35/13-02N 12 West Irving Street
(Chevy Chase Village Historic Dist.)

HISTORIC PRESERVATION COMMISSION STAFF REPORT

PROPOSAL: Alter rear windows as part of kitchen renovation

RECOMMEND: Approval with Conditions:

REAR ELEVATION

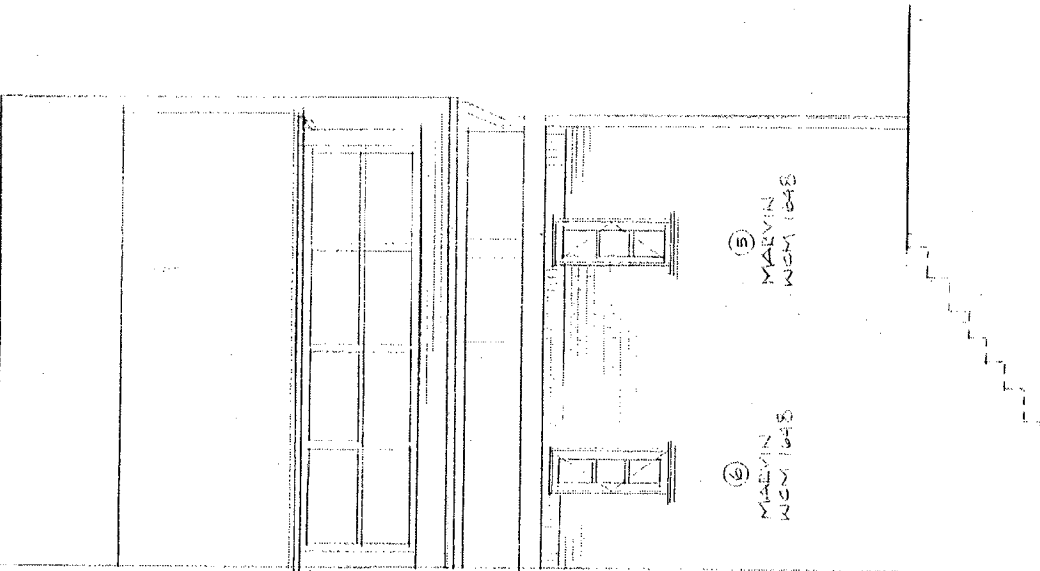
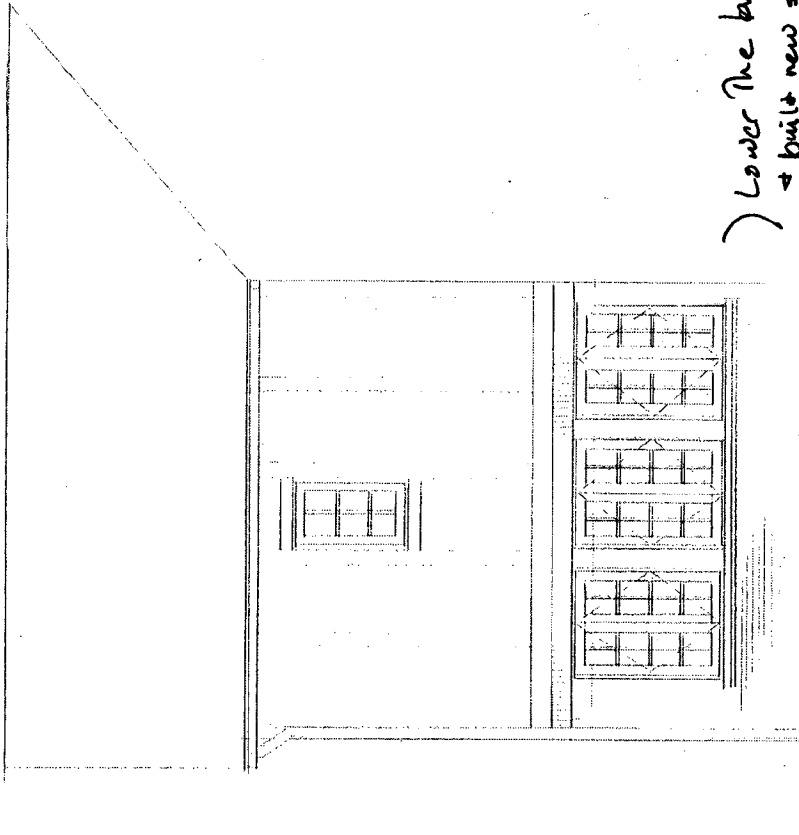
1. The new windows will be simulated true-divided light, with exterior and interior fixed muntin bars to match the original windows. The window pattern will match the existing window pattern of 6/6-for double-hung, or 6-light casement windows (as per Circle 8-9, 13-16).

The proposed work involves compatible alterations to the original house. All of the proposed work is at the rear of the house, and is not at all visible from the public right-of-way. The applicant will match the brick work, and match the small-paned window pattern of the original windows. The window specification doesn't actually address true-divided light or simulated true divided light, so staff recommends clarifying that in the Conditions of approval.

1. The new windows will be simulated true-divided light, with exterior and interior fixed muntin bars to match the original windows. The window pattern will match the existing window pattern of 6/6 for double-hung, or 6-light casement windows (as per Circle 8-9, 13-16).
